LSC Responses to Deviation No 1 Comments

Deviation No. 1 - Exhibit 1

Intersection Spacing Along an Urban Major Collector

Monument Ridge East (LSC# S234450)

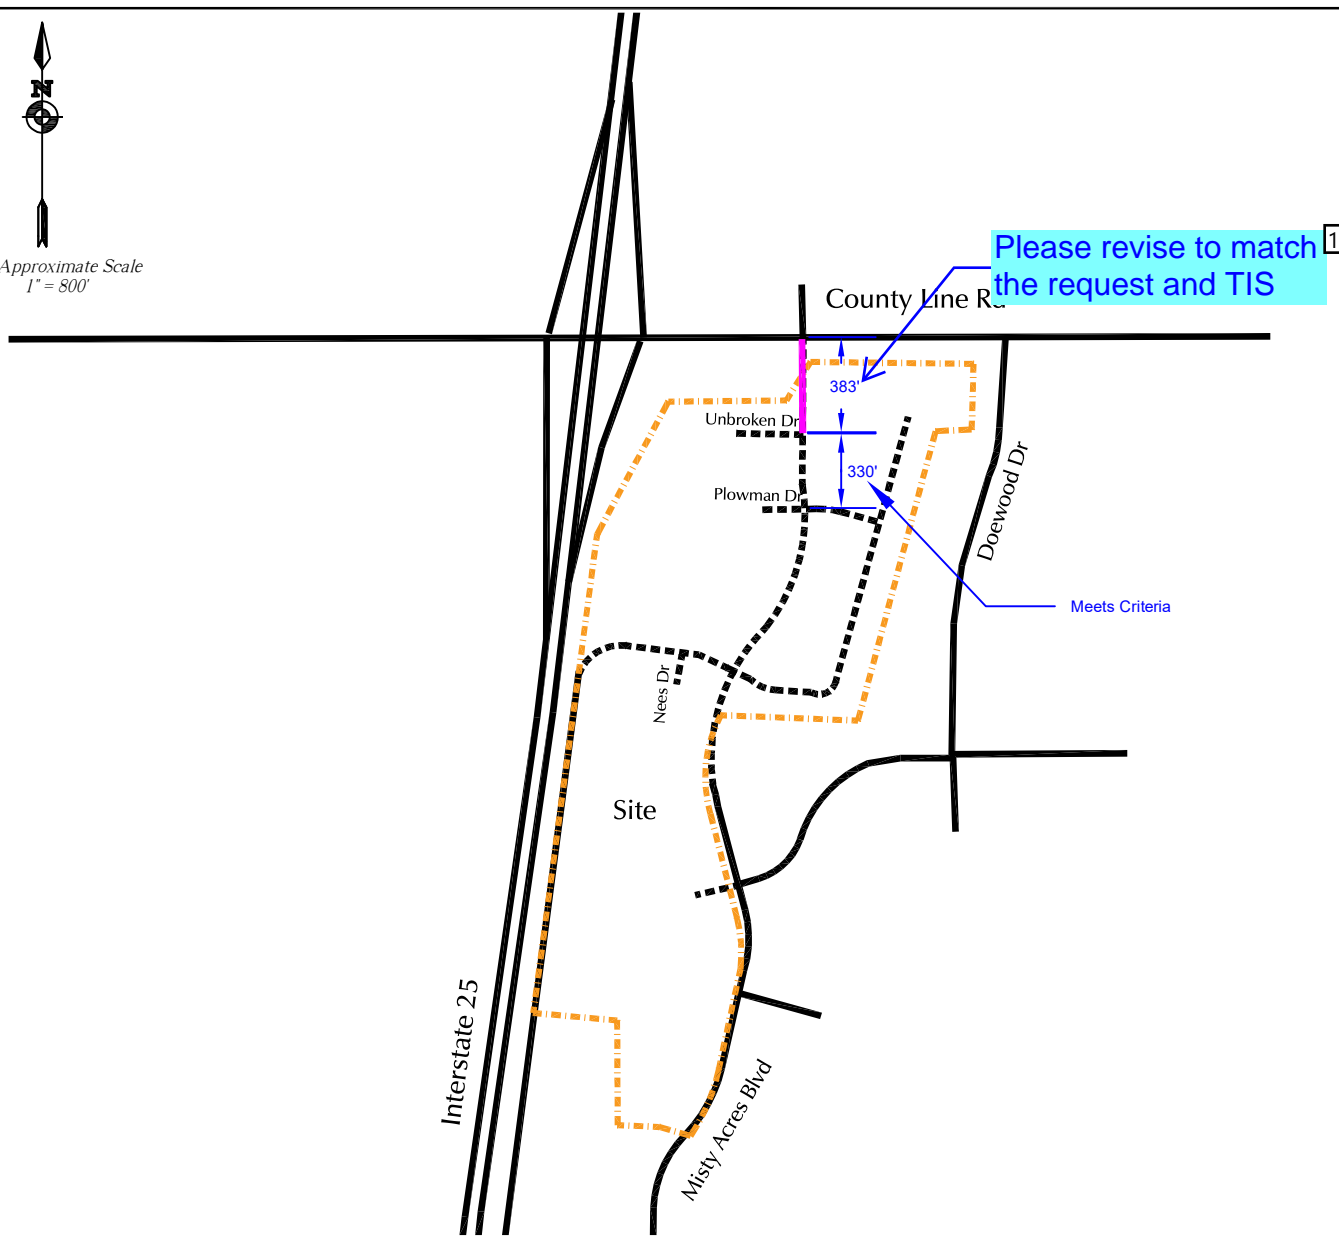
Please revise to match the request and TIS

Please revise to match the request and TIS

Spacing has been updated to be 395 ft, which is consistent with other figures
